SUNDRY NOTICES AND REPORTS ON WELLS

8. Well Name and No.
MRU 211

LINN PROPOSES TO P&A THE MRU #211

** BLM REVISED ** BLM REVISED ** BLM REVISED ** BLM REVISED ** BLM REVISED **

Proposed Wellbore Schematic

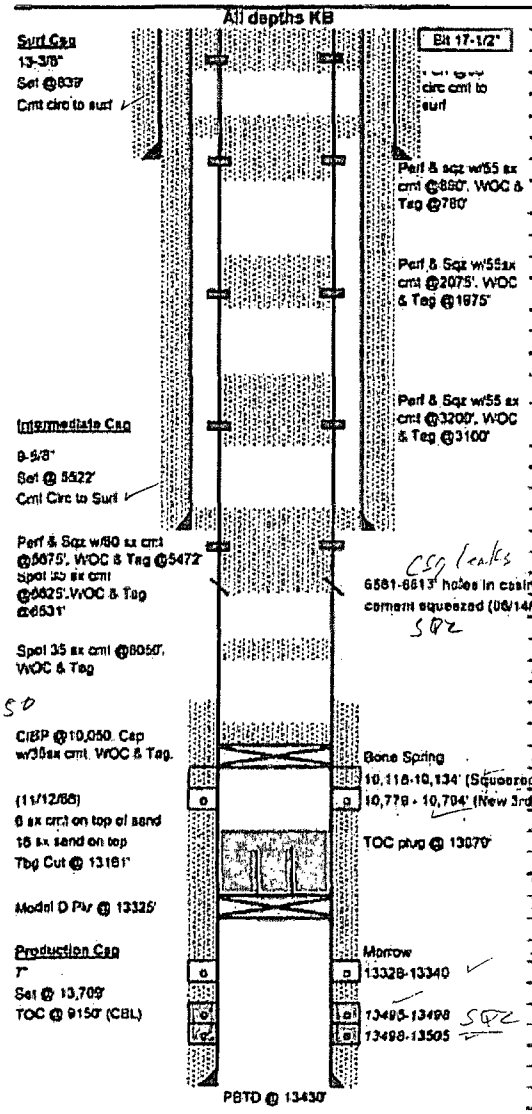
MIRU PLUGGING EQUIPMENT. ND WH & NUBOP.
RIH & SET CIBP @ 10,050'. CAP W/ 35 SX CLASS 'H' CMT. WOC & TAG.
CIRC HOLE W/ MUD LADEN FLUID.
POOH TO ~~8050'~~. SPOT 35 SX CLASS 'H' CMT. WOC & TAG. Perf @ 8100'. SQZ cmt to 7920'. WOC Tag
POOH TO 6625'. SPOT 35 SX CLASS 'C' CMT. WOC & TAG AT 6531'.
PERF @ 5675' (INT CSG SHOE). SQZ W/ 60 SX CLASS 'C' CMT. WOC & TAG @ 5472'.
PERF @ ~~3200~~' (BASE OF SALT). SQZ W/ 55 SX CLASS 'C' CMT. WOC & TAG @ 3100'. Perf @ 3250' (130' plug)
PERF @ ~~2075~~' (TOP OF SALT). SQZ W/ 55 SX CLASS 'C' CMT. WOC & TAG @ 1975'. Perf @ 2125' (130' plug)
PERF @ 890' (SURF CSG SHOE). SQZ W/ 55 SX CLASS 'C' CMT. WOC & TAG @ 780'.
PERF @ 60' & CIRC CMT TO SURFACE INSIDE AND OUTSIDE 7" CSG.
